Title : Changed electrodes (spiral)
Model : B and B HW-series (Norwegian and Marine machines)
Date : 19-11-2020

Reason for sending you this information

B : 6.305.052.000 Spiral electrode set (coffee part)

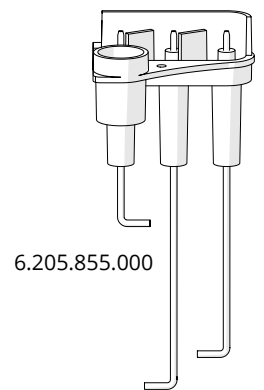
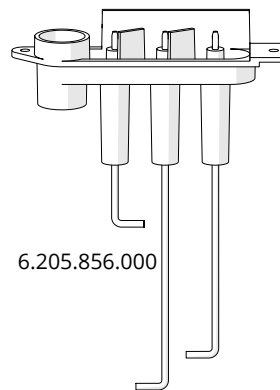
We want to inform you that we have changed the electrodes for the Norwegian and Marine machines.

The reason is the poor conductivity of the standard electrodes when the water hardness is very low.

To prevent this in the future, we have introduced the new electrodes with a larger surface.

We use these new electrodes in the Norwegian and marine machines with serial number 020002178448 and higher.
